SERVICE BULLETIN

Classification: BT18-003	Reference: NTB18-032	Date: April 12, 2018
------------------------------------	--------------------------------	--------------------------------

ALTIMA AND MAXIMA; NOISE FROM TRUNK AREA

Figure 7

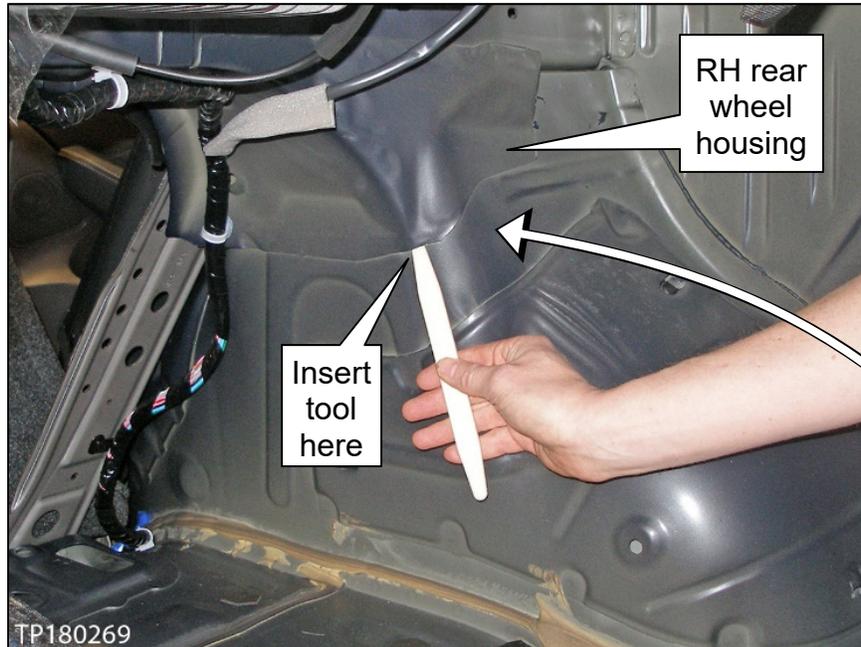
8. Insert a plastic interior pry tool where shown in Figures 7 and 8, and then carefully widen the gap between the two body panels about 3/32 inch (3 mm).

- Make sure to insert the plastic interior pry tool at least 1³/₈ inches (35 mm) up into the gap, and then spread apart.

CAUTION: Do NOT use a metal pry tool. It may puncture through the body panels. Use an interior plastic pry tool similar to the one shown below Parts Information.

Figure 8

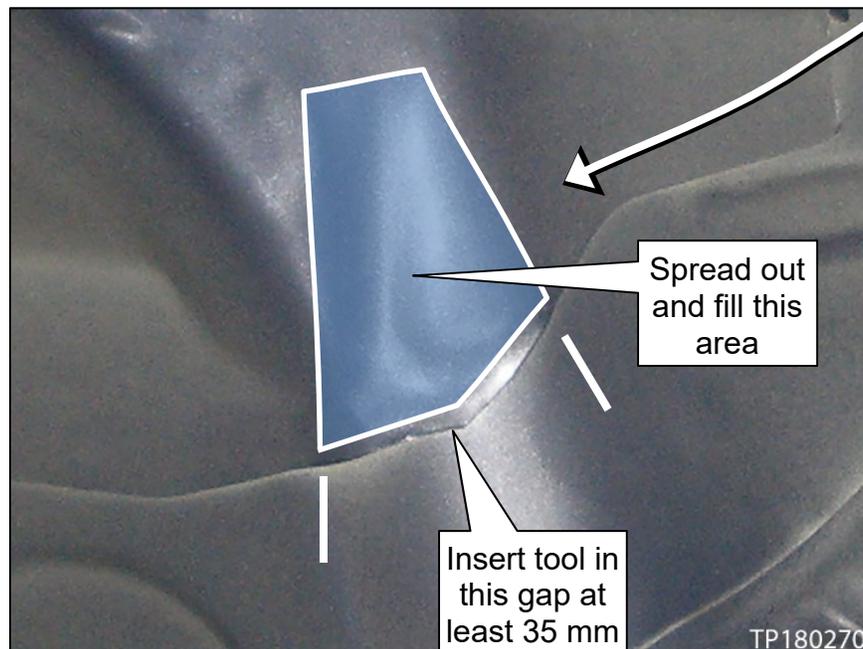
9. Widen the gap and fill the area where shown in Figure 8 with expanding foam.

- See Parts Information for recommended products.
- Spray the expanding foam into the gap just widened.
